### NOTICE TO ALL CONTRACTORS:

**Proposal #31: 2720-09-71, WISC 2026065**  
**V Menomonee Falls, Campbell Dr**  
**Butler Ditch Bridge P67-0775**  
**Local Street**  
**Waukesha County**

This is Addendum No. 02 which provides for the following:

**ADDENDUM NO. 02**

Addendum No. 02  
ID 2720-09-71  
Revised Sheet 10  
October 9, 2025

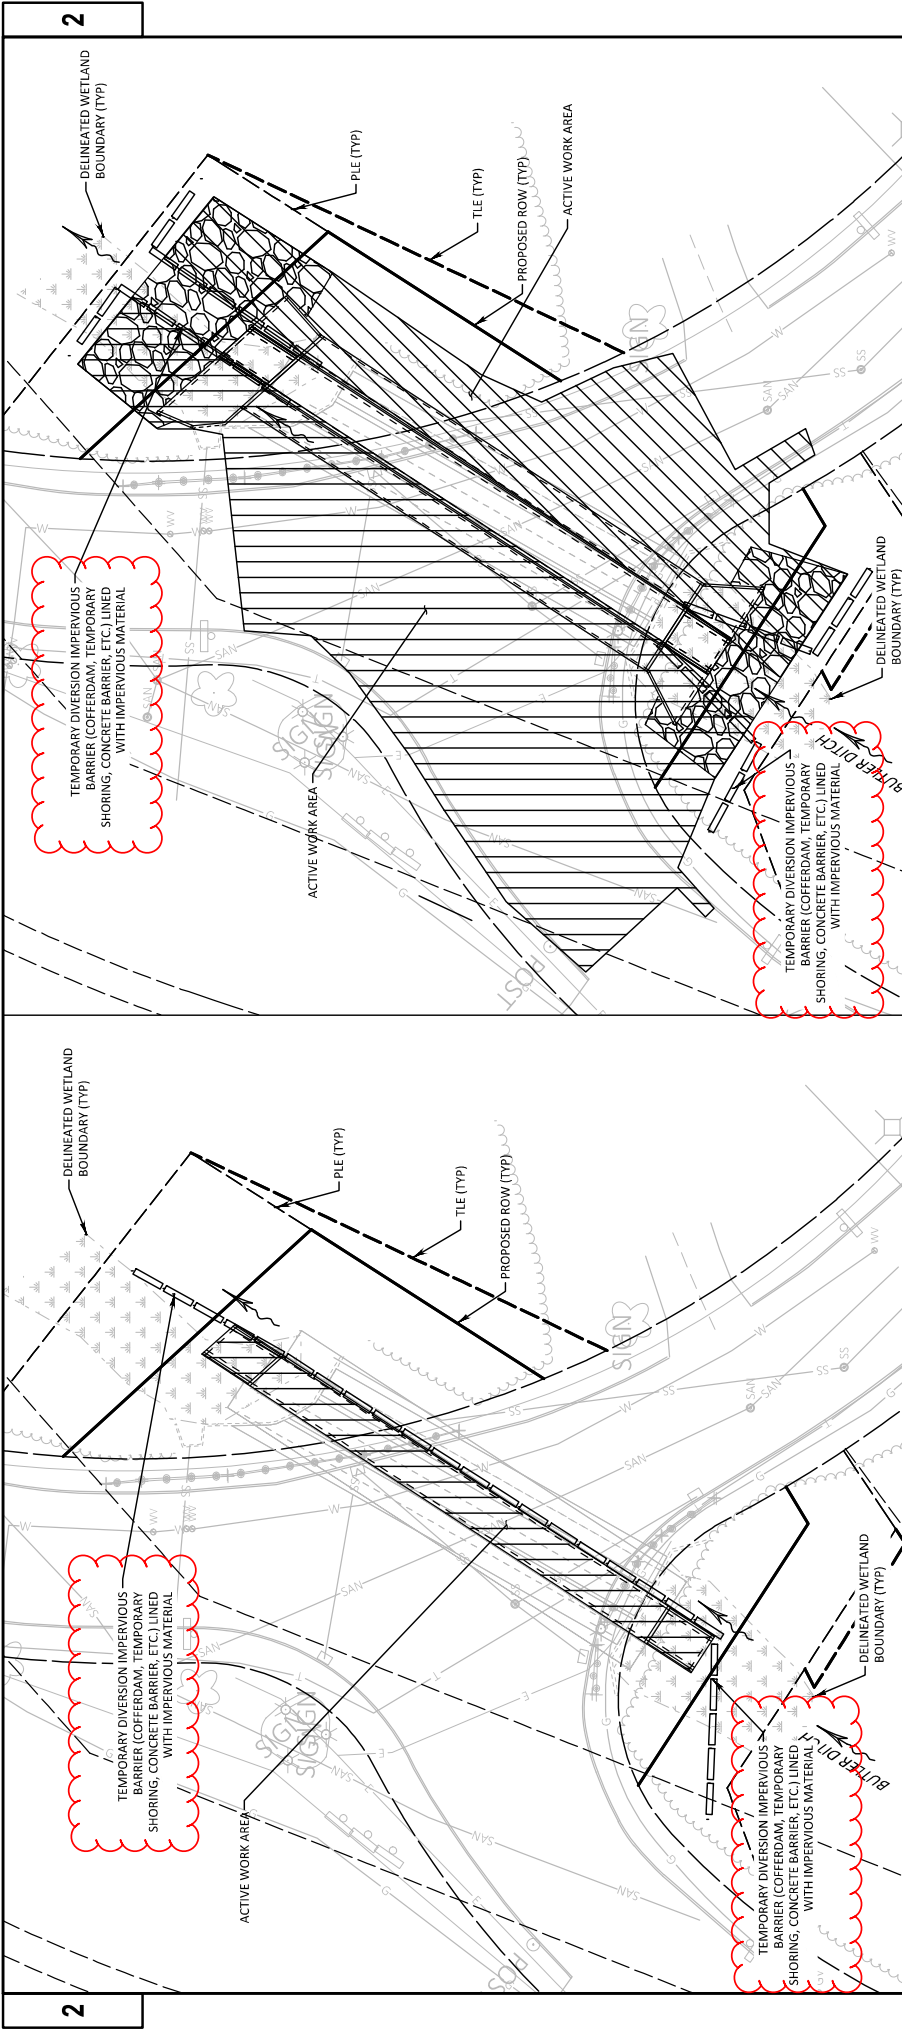
| <b>Revised Plan Sheets</b> |                                                                                                                                                                                   |
|----------------------------|-----------------------------------------------------------------------------------------------------------------------------------------------------------------------------------|
| 10                         | Temporary Water Diversion (Revised diversion notes to correspond with changes made to revised article)                                                                            |

THE STRUCTURE PLANS HAVE BEEN DETAILED FOR PLACEMENT OF THE MIDDLE CELL AND APRONS FIRST. WORK FOR THE TEMPORARY WATER DIVERSION TECHNIQUES IMPLEMENTED WILL BE PAID UNDER "TEMPORARY WATER DIVERSION". REFER TO "TEMPORARY WATER DIVERSION" IN THE SPECIAL PROVISIONS FOR ADDITIONAL DETAILS AND REQUIREMENTS.

THIS DRAWING DEPICTS AN OPTION OF A TEMPORARY CHANNEL FOR WATER DIVERSION. CONTRACTOR IS RESPONSIBLE FOR DEVELOPING A PHASED WATER DIVERSION PLAN COMPATIBLE WITH THEIR PROPOSED WORK PLAN AND SUBMITTING THE DIVERSION PLAN WITH ECP FOR APPROVAL PRIOR TO COMMENCING WORK.

THE TEMPORARY WATER DIVERSION PLAN MUST BE CAPABLE OF DIVERTING THE 2-YEAR RAINFALL EVENT STREAM FLOW. FISH AND AQUATIC SPECIES THAT BECOME STRANDED IN DEWATERED AREA OR TEMPORARY CHANNELS SHOULD BE CAPTURED AND RETURNED TO THE ACTIVE CHANNEL IMMEDIATELY.

Addendum No. 02  
ID 2720-09-71  
Revised Sheet 12  
October 9, 2025

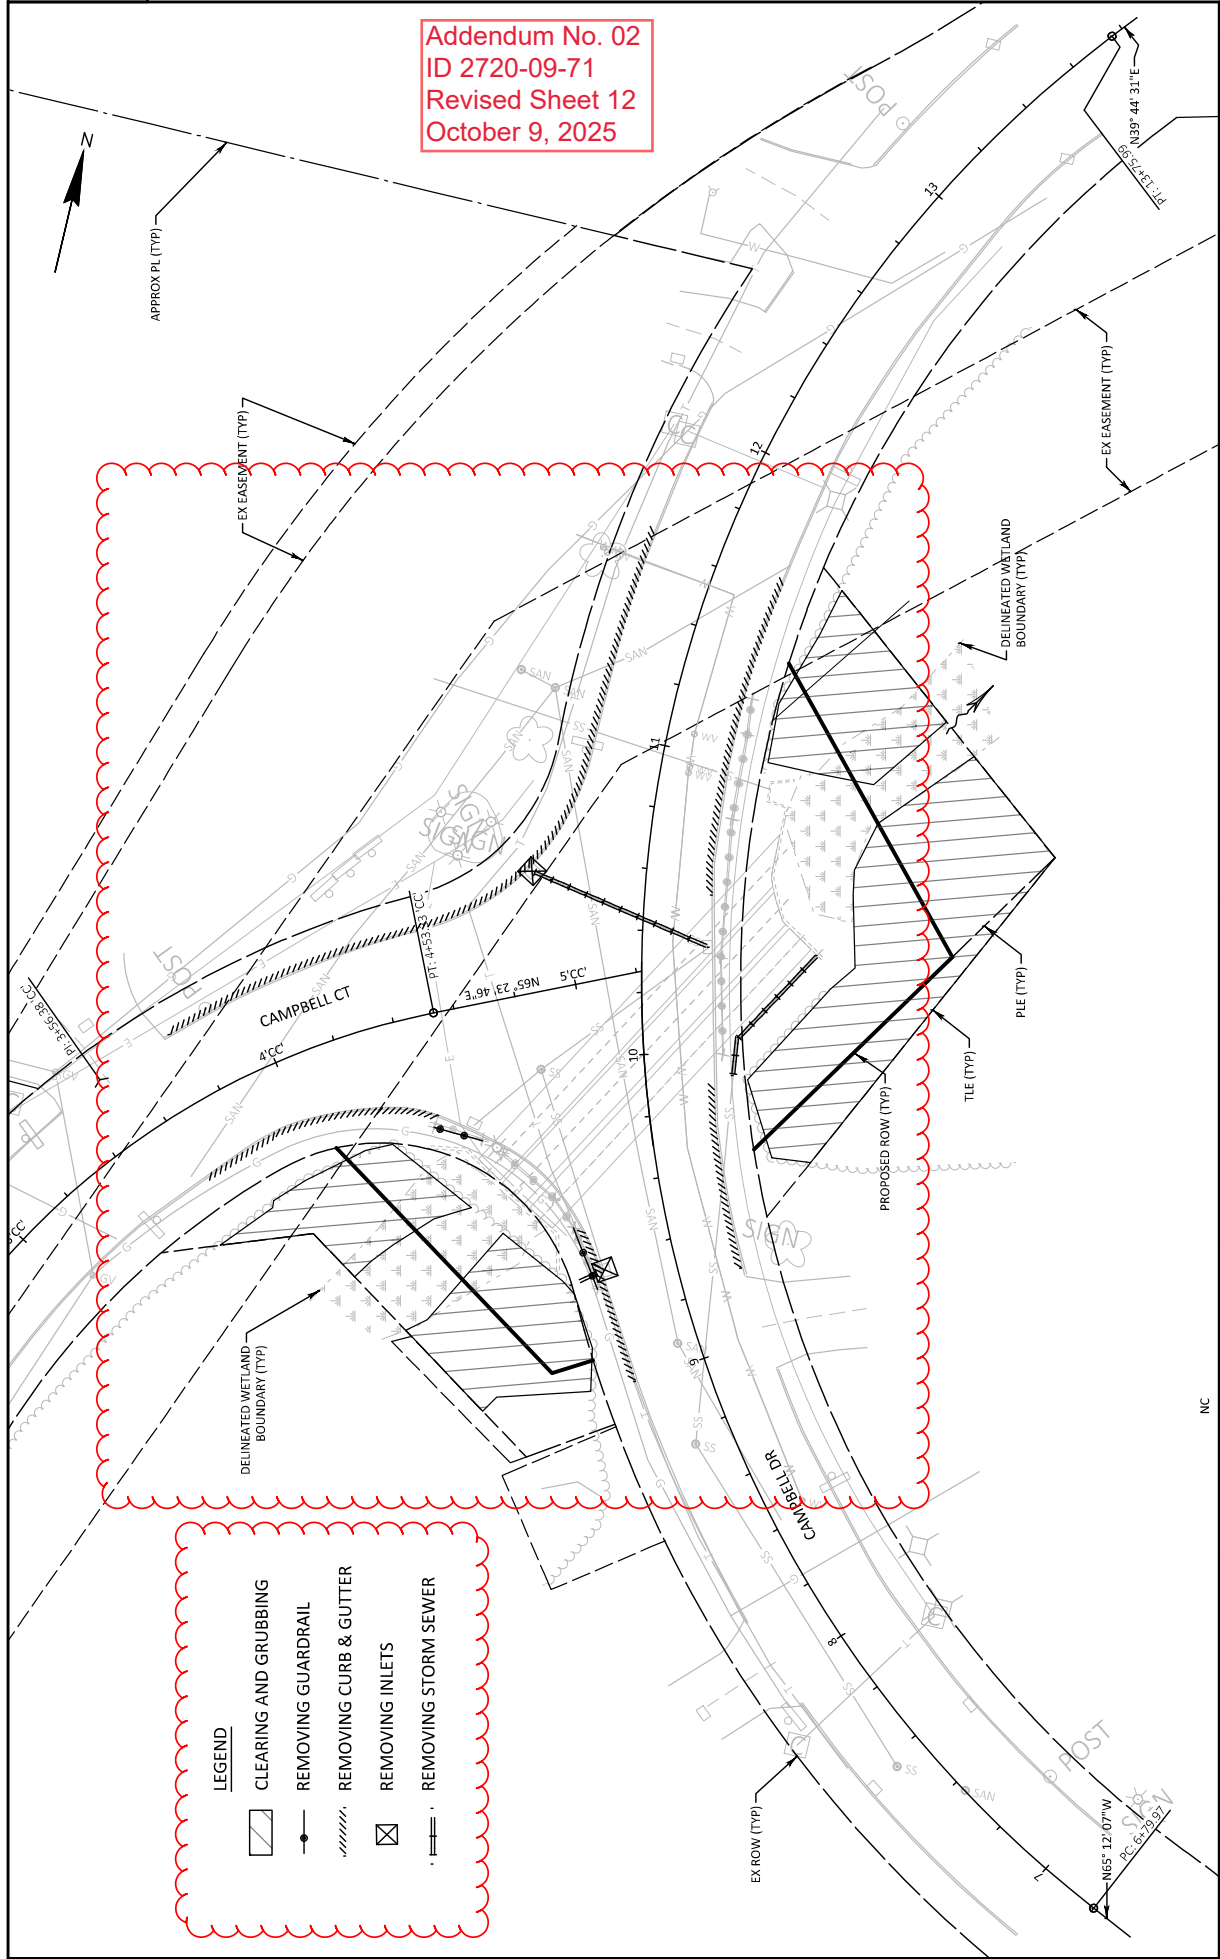
| <b>Revised Plan Sheets</b> |                                                                                                                                                                                   |
|----------------------------|-----------------------------------------------------------------------------------------------------------------------------------------------------------------------------------|
| 12                         | Removals (revised to show existing guardrail, curb & gutter removal limits, storm sewer removals based on existing site conditions)                                               |
